Recall – SureLock II Weight Pocket Handles
** Aqua Lung Consumer Notice **

## Recall – SureLock II Weight Pocket Handles

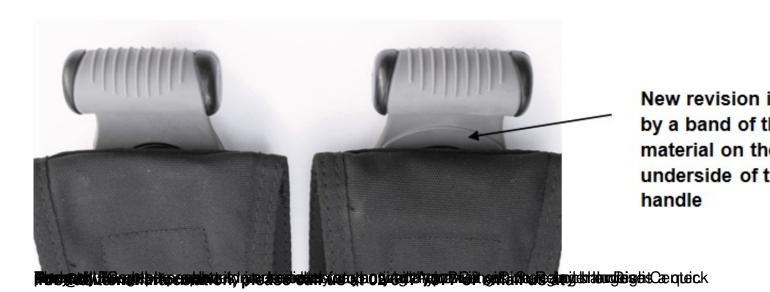
Aqua Lung is conducting a voluntary recall of SureLock II weight pocket handles. Sure Lock II is the mechanical weight release system found on most Aqua Lung buoyancy compensators (BCs) beginning in 2009. Aqua Lung is concerned about the rubber handle pulling off of the plastic Sure Lock II weight pocket assembly. If this were to occur during a dive, the weight pocket would be left engaged inside the BC. There are no known occurrences of this happening underwater, and there have not been any reported injuries, but Aqua Lung believes that a recall is the safe and prudent thing to do.

Aqua Lung has made a revision to the handle assembly that strengthens it. A revised handle is easily recognized by a thickened band of rubber at the base of the handle.
